**Subject:** Inspection and replacement of spar spigot assemblies

**Concerning:** Model: ASTIR CS TCDS No.: 306  
- Series: - S/N:  
ASTIR CS 1001-1536  
ASTIR CS 77 1601-1844  
ASTIR CS Jeans 2001-2248  
CLUB ASTIR II 5001-5061 (Suffix "C")  
STANDARD ASTIR II 5001-5061 (Suffix "S")  
G 102 CLUB ASTIR III 5501 & up (Suffix "C")  
G 102 CLUB ASTIR IIIb 5501 & up (Suffix "Cb")  
G 102 STANDARD ASTIR III 5502 & up (Suffix "S")

Model: SPEED ASTIR II TCDS No.: 320  
- Series: - S/N:  
SPEED ASTIR II 4001-4027  
SPEED ASTIR IIB 4028-4107

Definition of the distance b

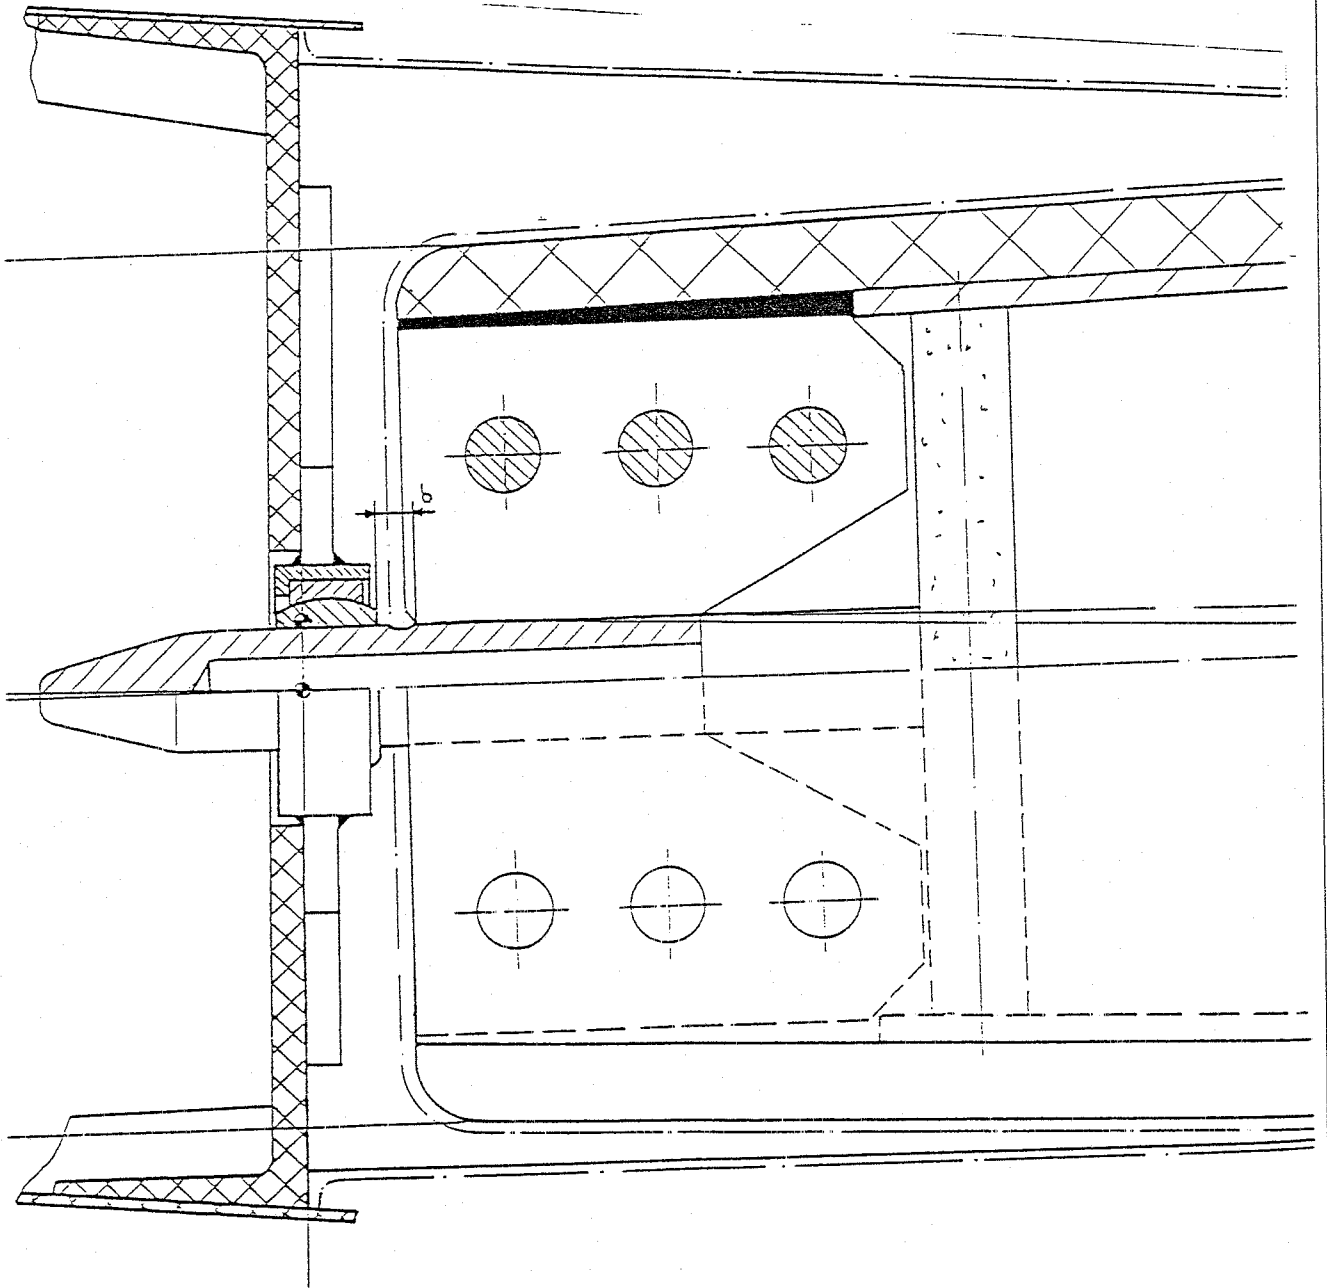
If no crack is discovered and if the distance between spigot plates and swivel bearing is (refer to figure on page 3):

- $b \leq 10$  mm: Carry out Action 2 not later than 31 December 1992
- $b > 10$  mm: Carry out Action 2 not later than 30 June 1991

If a crack is discovered and if the distance between spigot plates and swivel bearing is  $b \leq 10$  mm, the crack may initially be blended out (refer to page 4 for procedure):

- Removal of crack is possible:  
Carry out Action 2 not later than 31 December 1992  
Warning: After blending, check that dimension  $b$  is still  $\leq 10$  mm.
- Removal of crack not possible:  
Carry out Action 2 immediately

If a crack is discovered and if the distance between spigot plates and swivel bearing is  $b > 10$  mm, Action 2 must be carried out immediately.

2. Replacement of the spar spigot assembly  
Replace the spar spigot assembly in accordance with Installation Instruction No. 306-29/320-5.

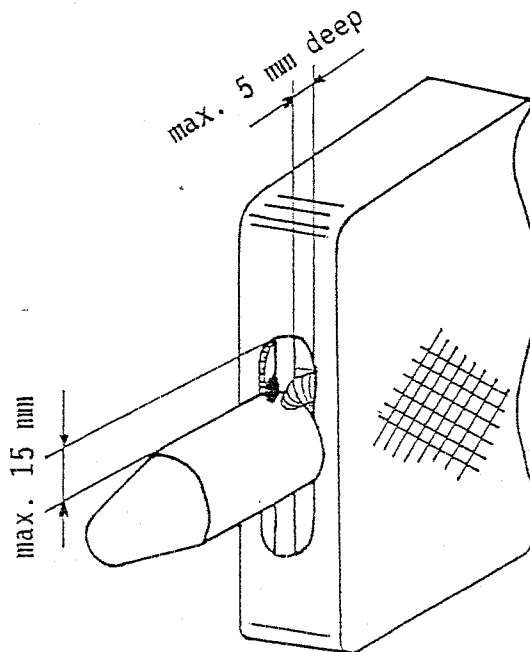
To perform the crack inspection the section of the wrapping around the main spigot has to be removed (max. 15 mm) and the adhesive material removed to expose the welding seam (max. 5 mm deep, see figure). Be very careful not to scratch or otherwise damage the spigot or plate.

If the weld seam is continuous around the plate, the complete toe of the welding seam has to be inspected. Grooves or nicks in the surface of the welding seam which are not part of a crack must be polished out and the crack inspection performed again.

Sketch mentioned below shows a cross section of blending out a crack.

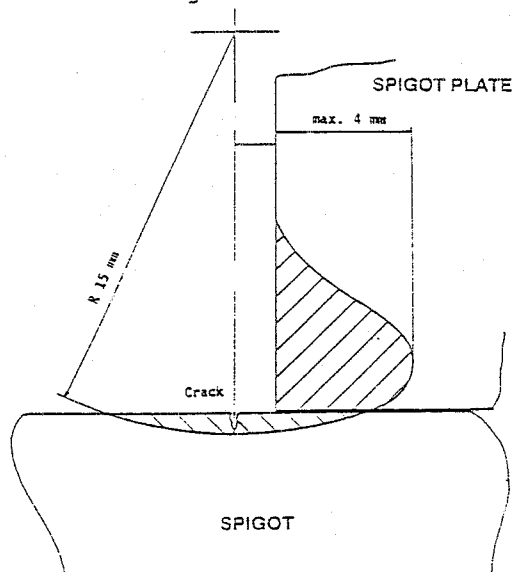
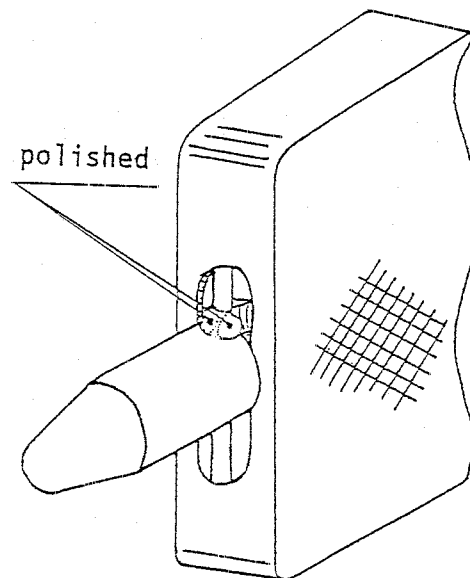
A crack may be blended out if the following conditions are fulfilled:

- \* crack on one side not deeper than 0.75 mm
- \* cracks on both sides not deeper than 0.5 mm each

Blending out should be done with grinding caps or equivalent. The grinded surface has to be polished.

Finally apply a coating of resin to the exposed area (wood and metal).
